Plan Commission

Agenda

Monday, June 26, 2017

SUBJECT: Recommendation regarding a Site Plan for a building addition for Green Bay Packaging INC at 2275 American Boulevard in De Pere (Parcel WD-L492-B-2). Submitted by GRAEF.

Building Addition and Modified Pavement, Driveway, and Storm Ponds

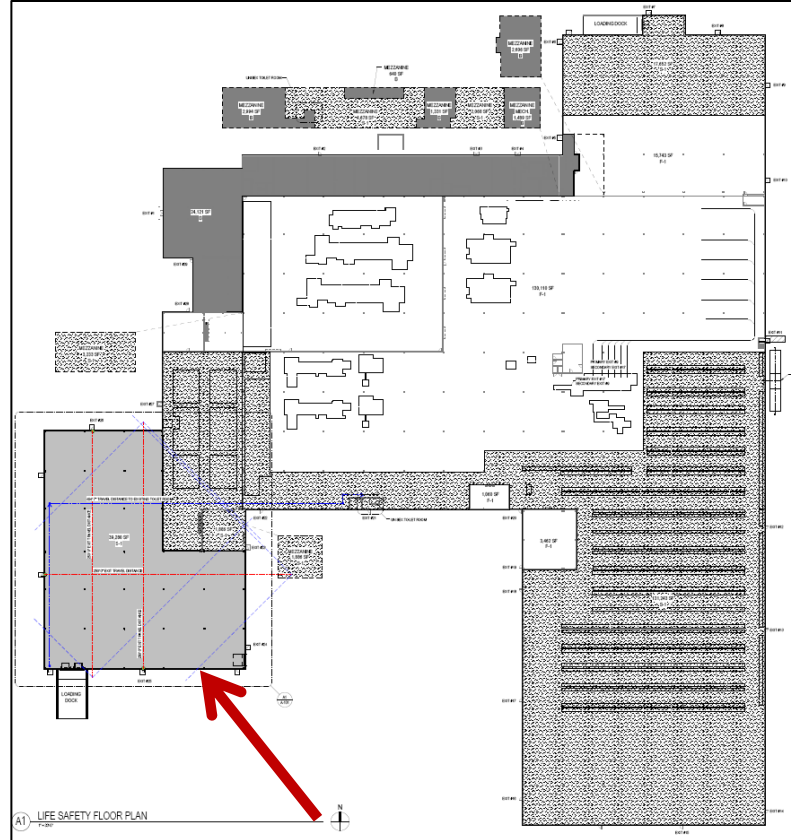
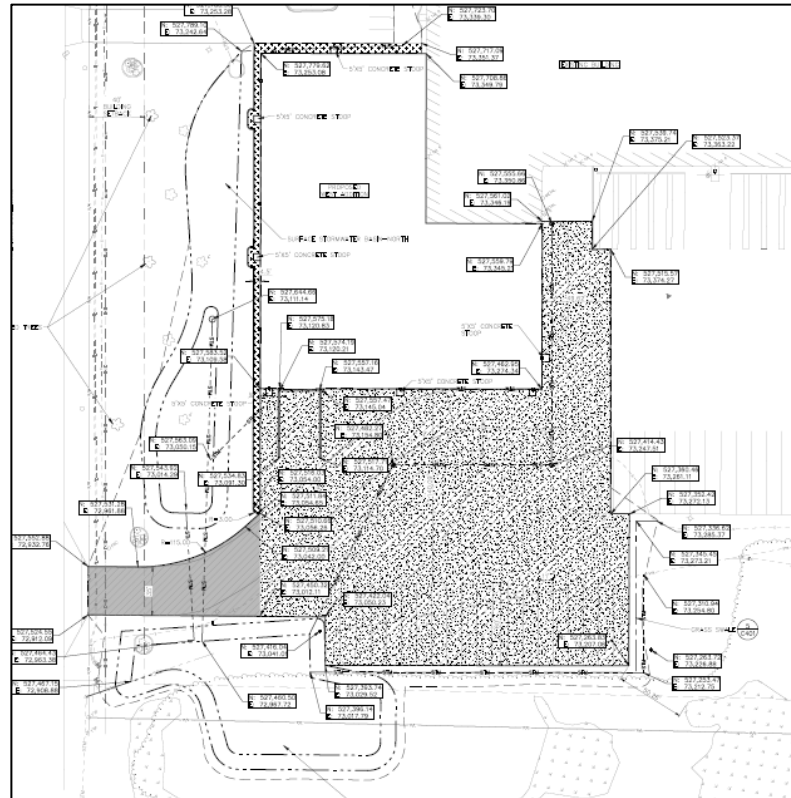
The site plan proposes a building addition, pavement for trucks, and storm water management. The site plan appears to be missing a landscaping plan.

1. Need to show appropriate boundaries of the property with dimensions.
2. The southern surface storm water basin crosses the property line. The City understands that Green Bay Packaging owns both properties. If both properties cease to remain in the same ownership, the property line that divides the southern surface water basin Green Bay Packaging will need to define the shared ownership of the basin.
3. Page C-200 needs to show 4-inch striping (typical)
4. What's happening to the electrical service that is shown to be abandoned on sheet C-101? To be reconnected and reused? Any work in City right-of-way will require excavation permit. Please call City of De Pere Engineering at 920-339-4061 for permitting needs. City requires 24 hour notice prior to construction.
5. The owner must establish a new storm water maintenance agreement for the proposed basins.

1. Contact the fire chief for site plan comments prior to obtaining permits.

1. No landscape plan found.

SHEET NO.  
1 of 5

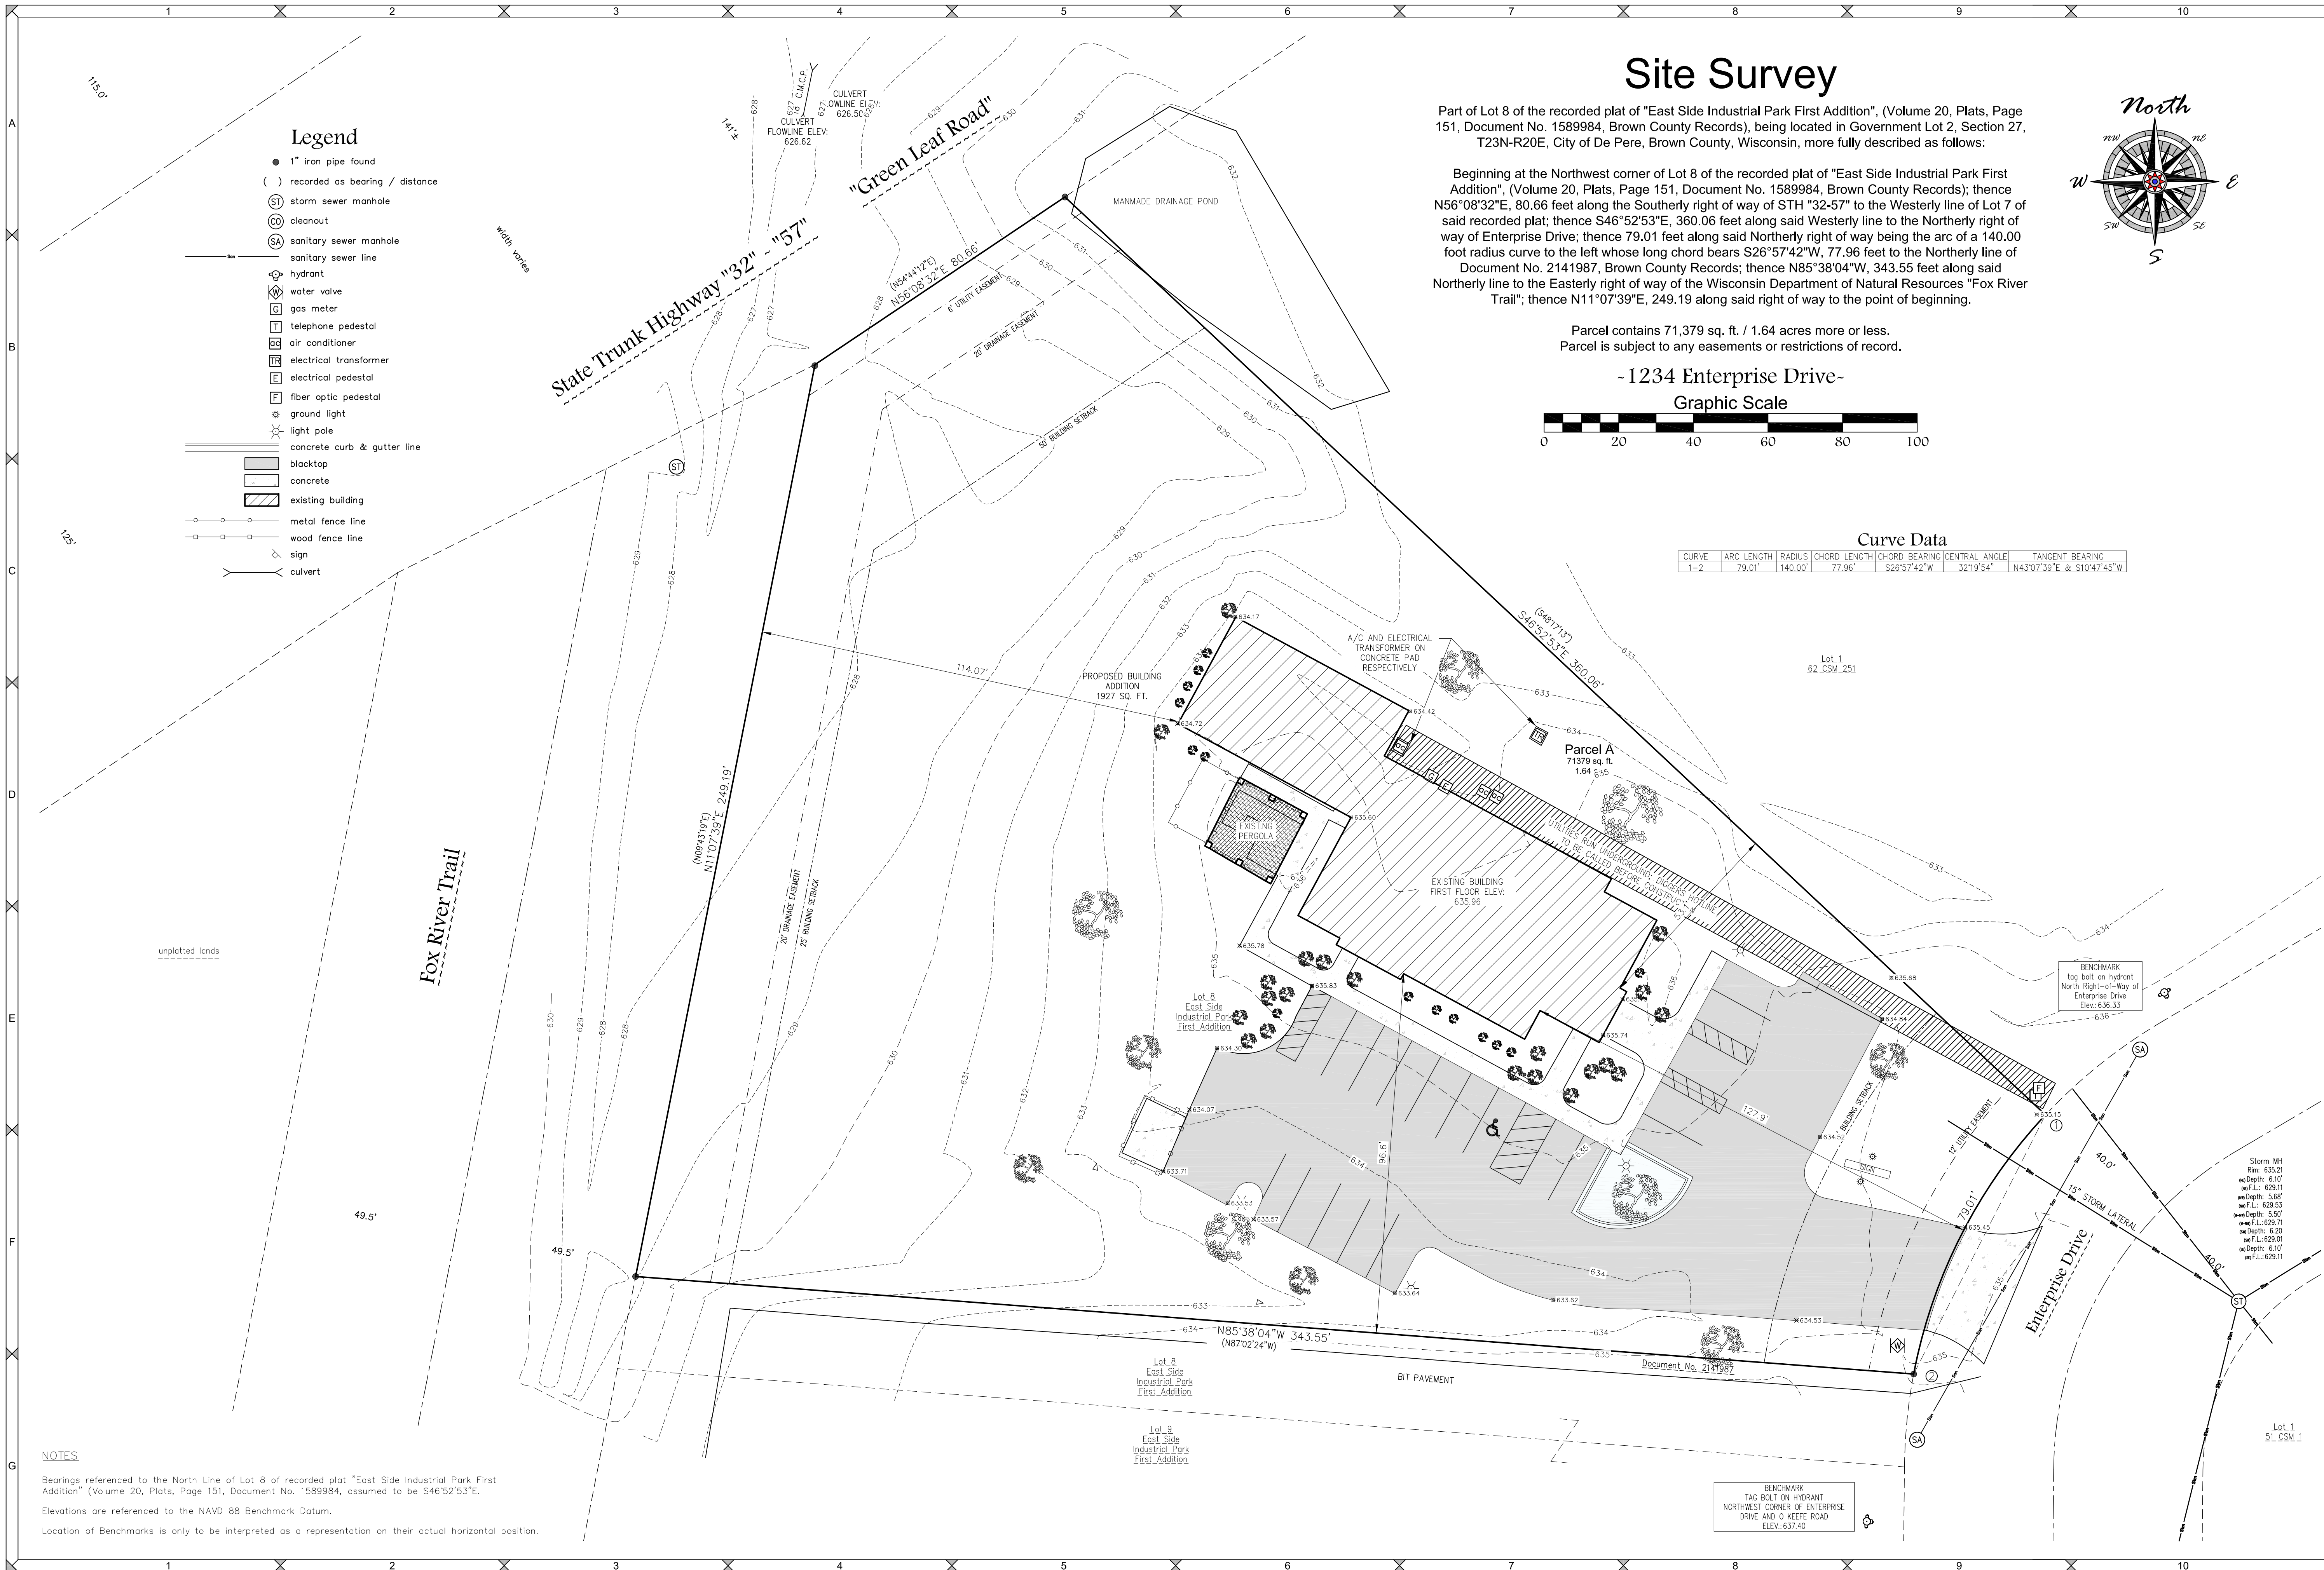
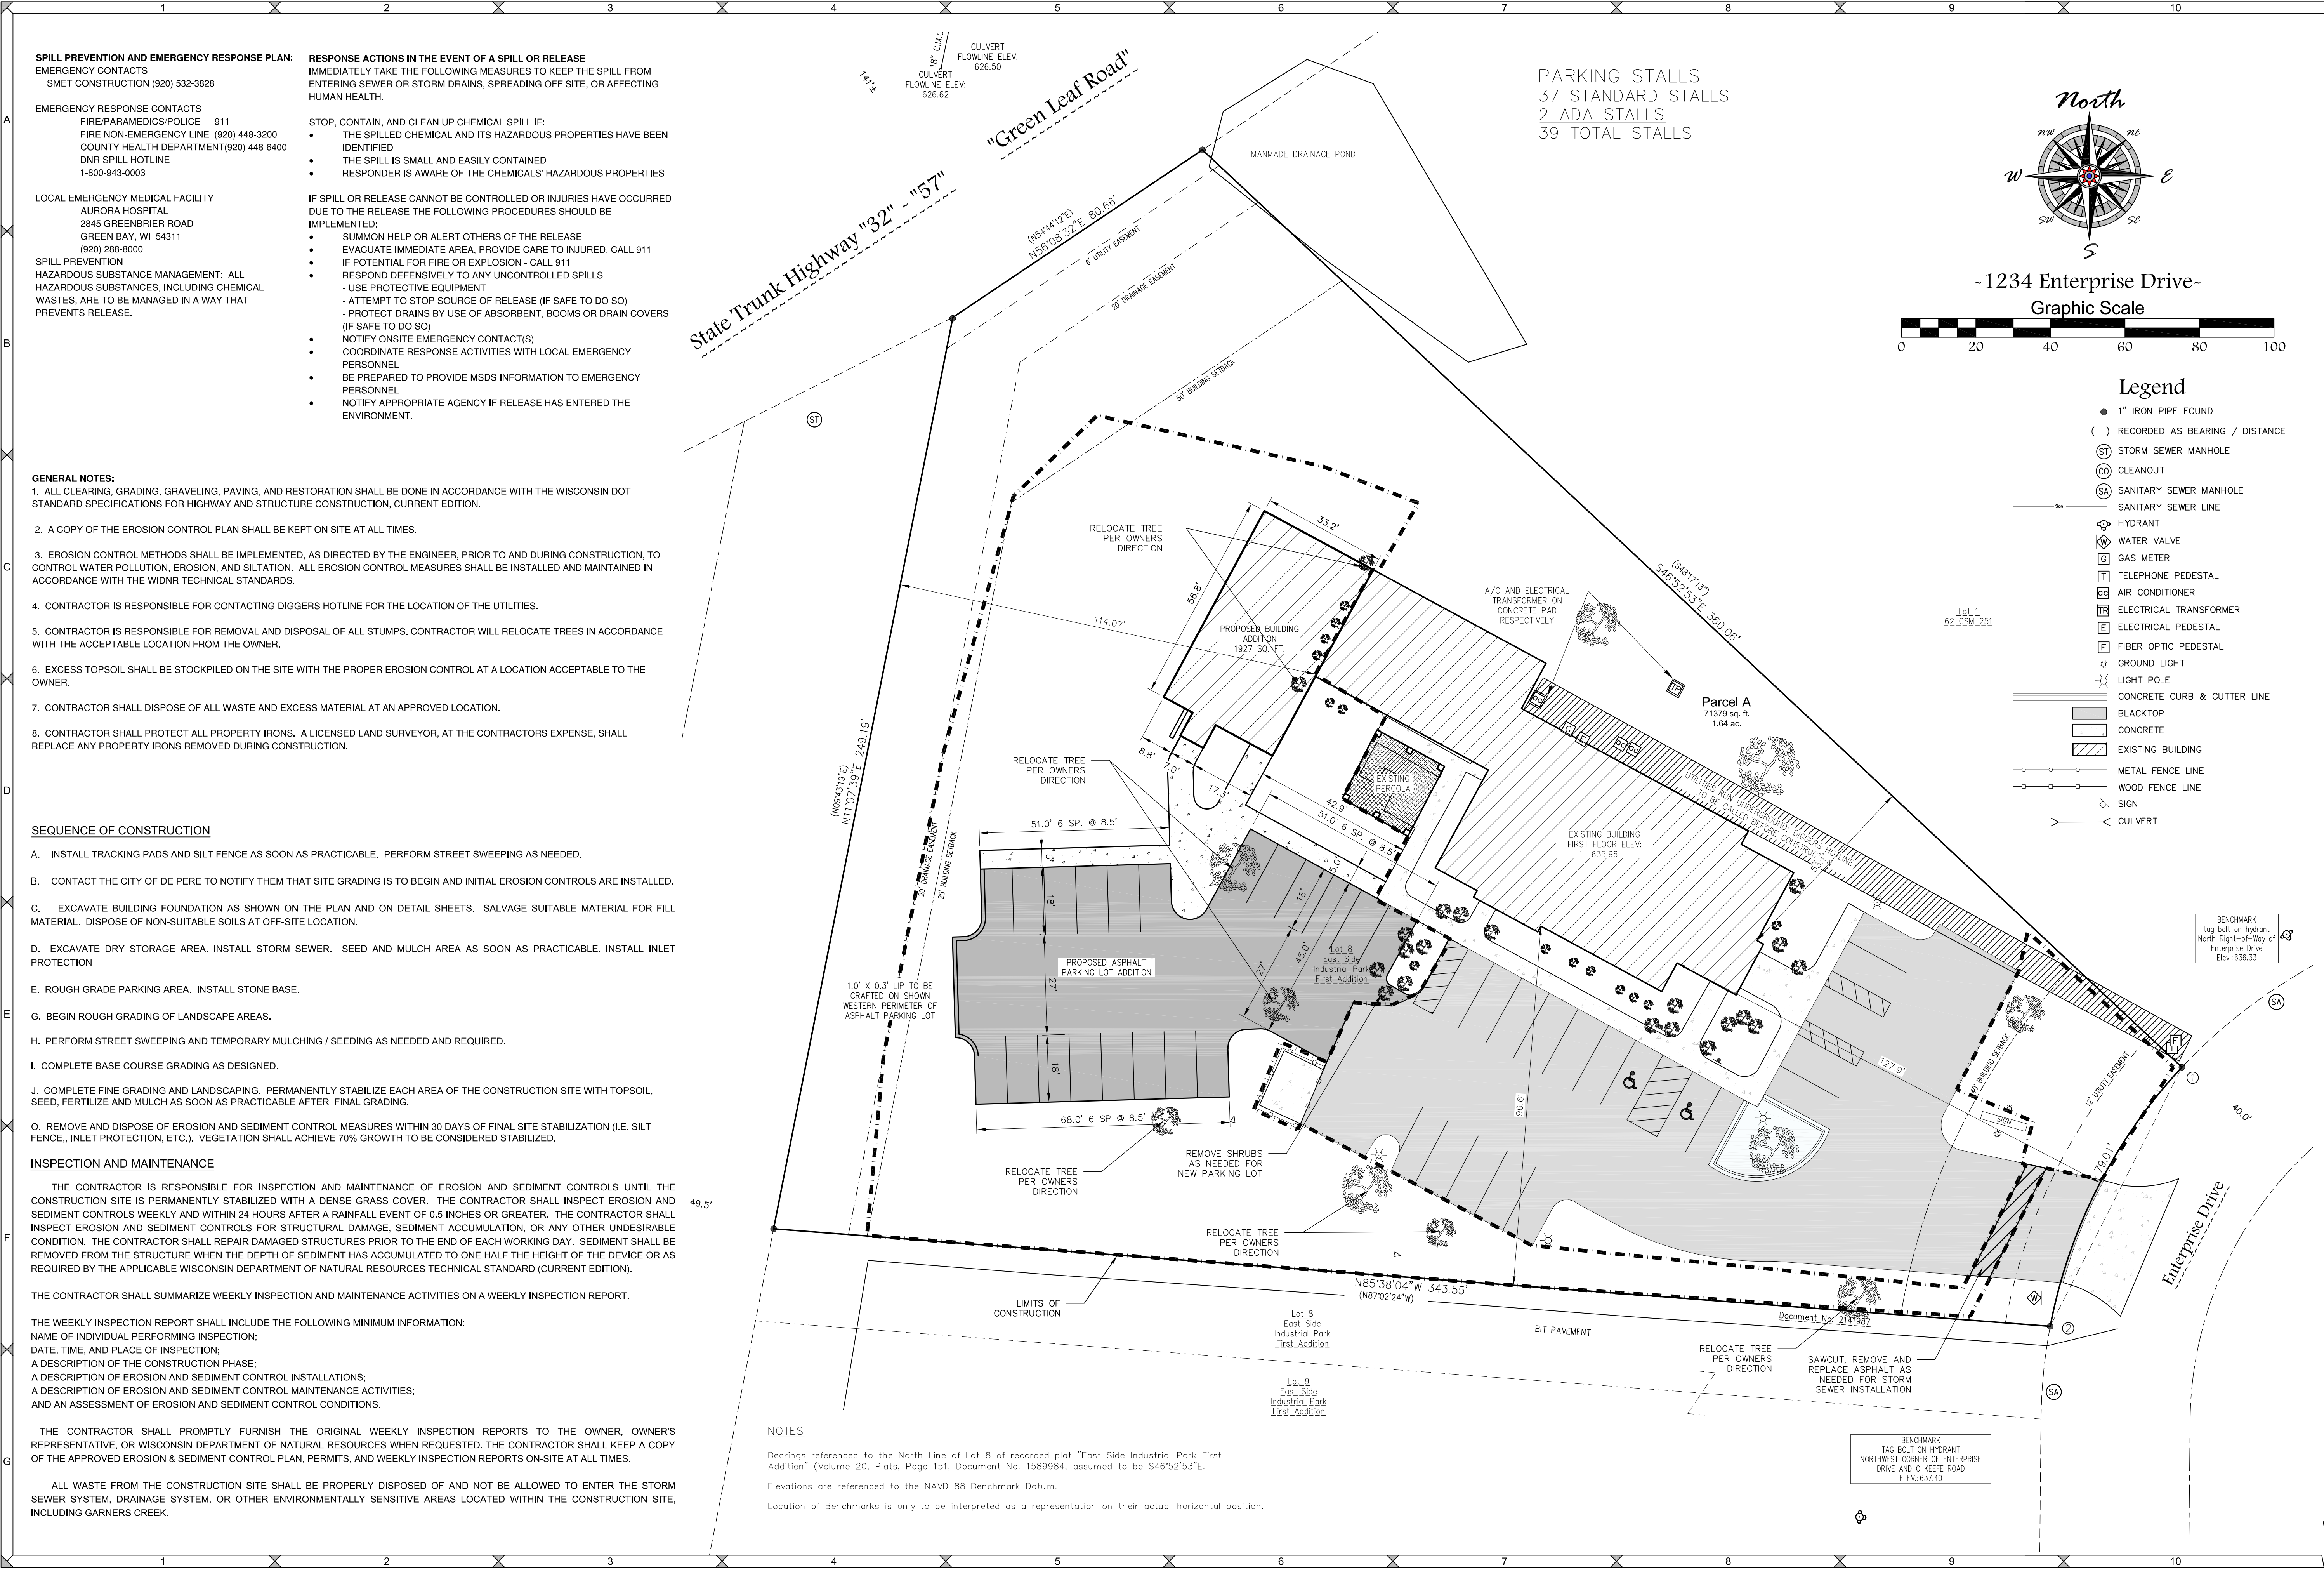
1. Provide a map of the critical route for flow off the site during construction to correspond with the WDNR Soil Loss & Sediment Discharge Calculation Tool. (SWMP)
2. Show City water main and water service to the property on all sheets.
3. Sheet 2 of 5: need to list striping as 4" Striping (TYP).

1. Identify the Code required number of parking stalls on Sheet 2 of 5 on the site plan. Offices require 4 spaces per 1,000 gross square feet of floor area (at least 24 for the site plan and 20 new stalls are proposed for a total of 39 stalls onsite).
